Our ref
DSA000008319

Date
22/02/2022

Proposal: Erection of 4 No dwelling with access from Hoe Lane and associated landscaping, including native orchards and wildflower meadows. This application is a Departure from the Development Plan and is in CIL zone 3 and is CIL Liable as new dwellings.

Site: Y/7/22/PL: - Land adjacent to Bonhams & Flints, Hoe Lane, Flansham PO22 8NP.

Southern Water MapGuide Browser

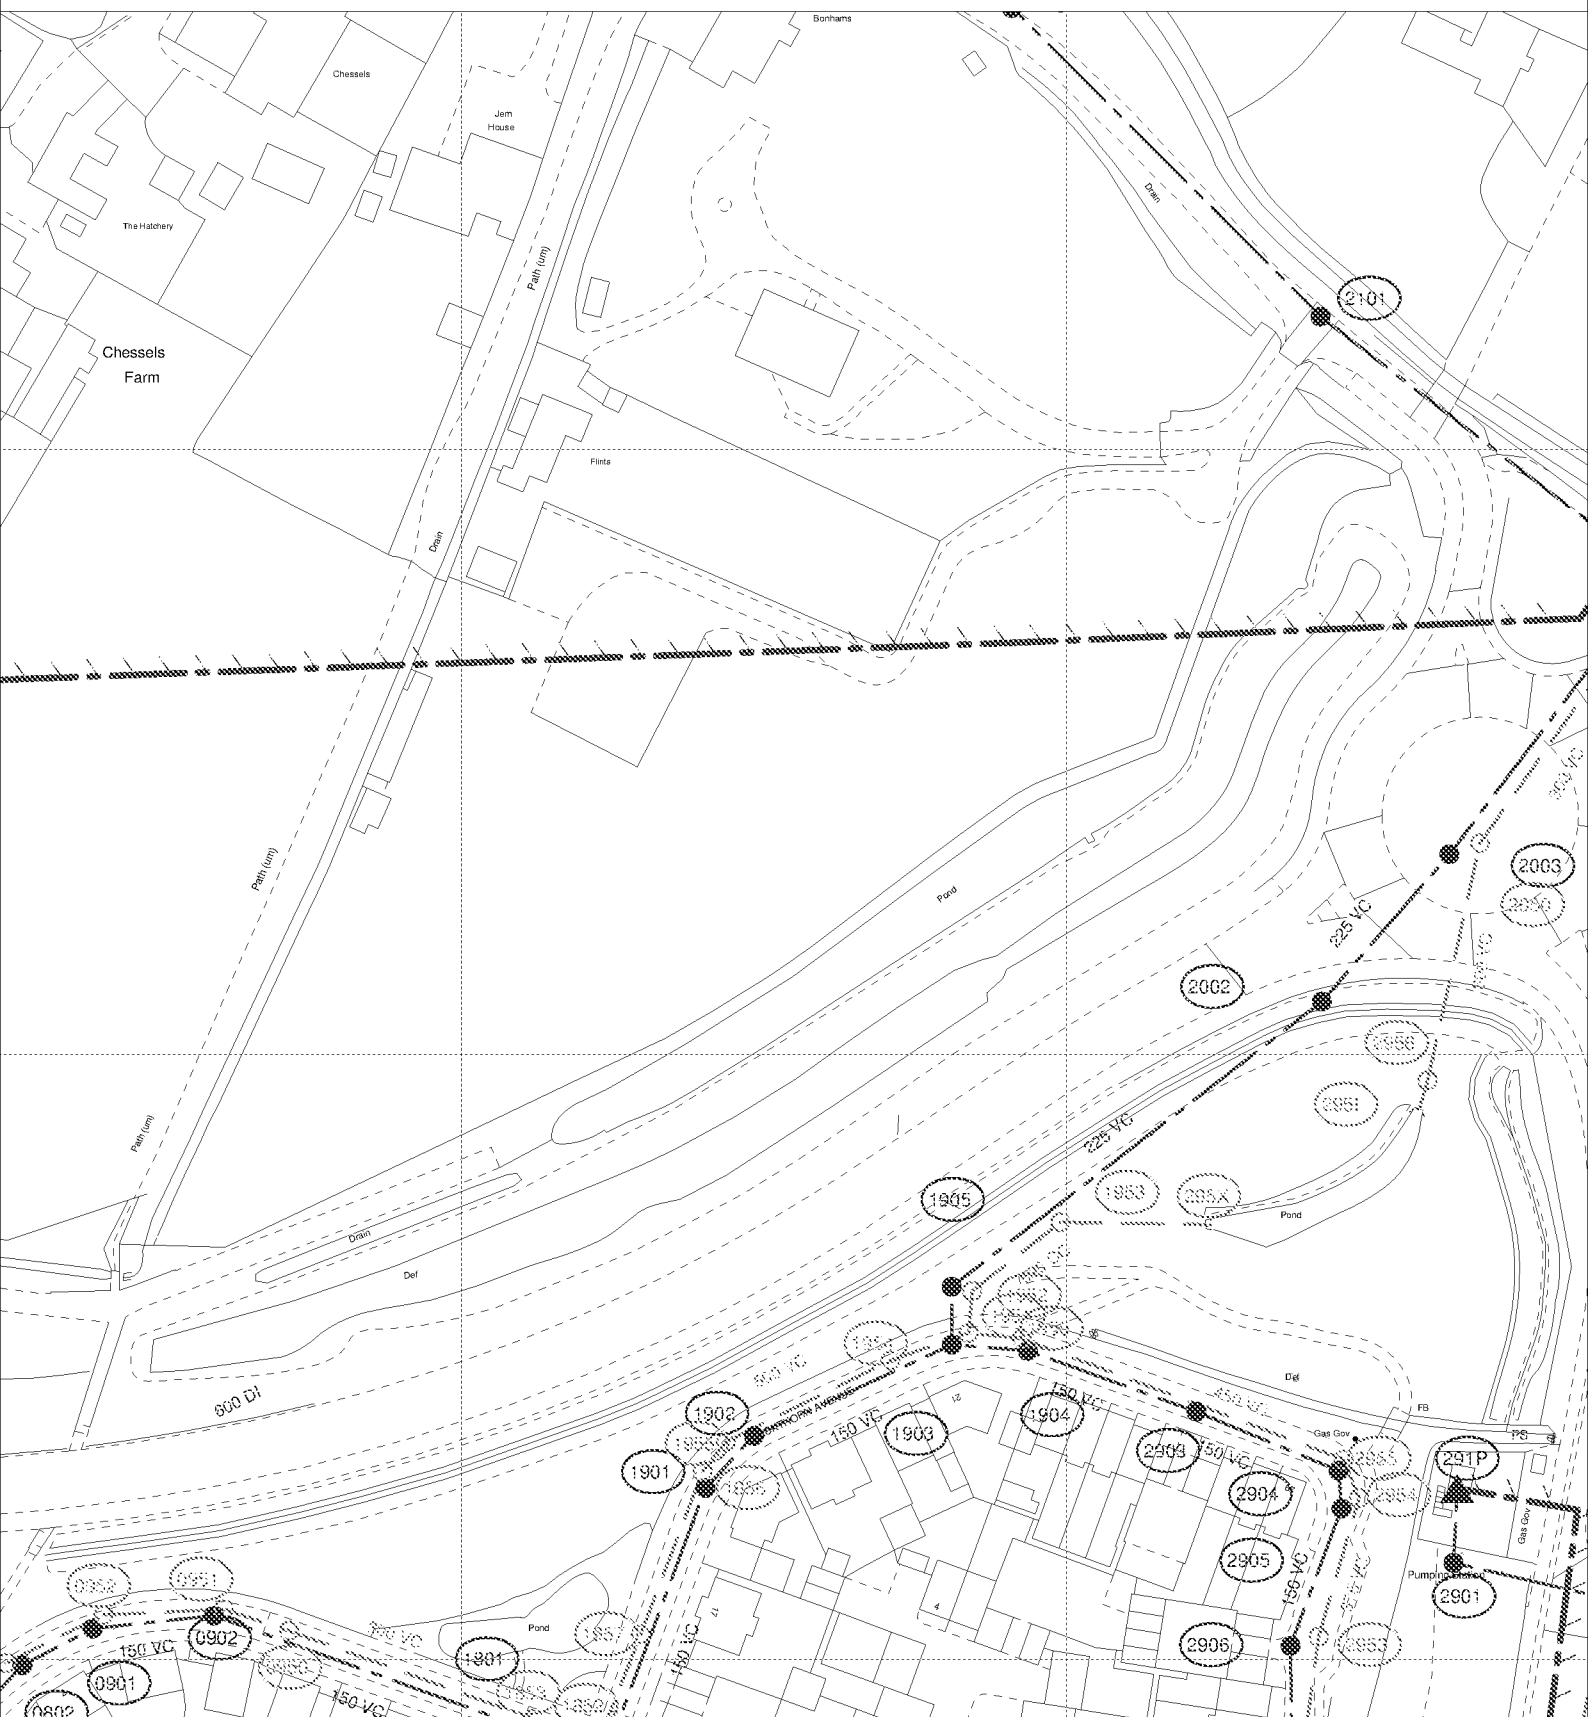
The attached plan shows that the proposed development will lie over an existing public foul rising main, which will not be acceptable to Southern Water. The exact position of the public apparatus must be determined on site by the applicant before the layout of the proposed development is finalised.

It might be possible to divert the rising main, so long as this would result in no unacceptable loss of hydraulic capacity, and the work was carried out at the developer's expense to the satisfaction of Southern Water under the relevant statutory provisions.

- The 600 public foul rising main requires a clearance of 3 metres on either side of the public rising main to protect it from construction works and to allow for future access for maintenance.
- No development or tree planting should be carried out within 3 metres of the external edge of the public rising main without consent from Southern Water.
- No soakaways, swales, ponds, watercourses or any other surface water retaining or conveying features should be located within 5 metres of public rising mains.
- All existing infrastructure should be protected during the course of construction works.

Alternatively, the applicant may wish to amend the site layout, or combine a diversion with amendment of the site layout. If the applicant would prefer to advance these options, items above also apply.

In order to protect drainage apparatus, Southern Water requests that if consent is granted, a condition is attached to the planning permission; for example, the developer must advise the local authority (in consultation with Southern Water) of the measures which will be undertaken to divert the public sewers, prior to the commencement of the development.
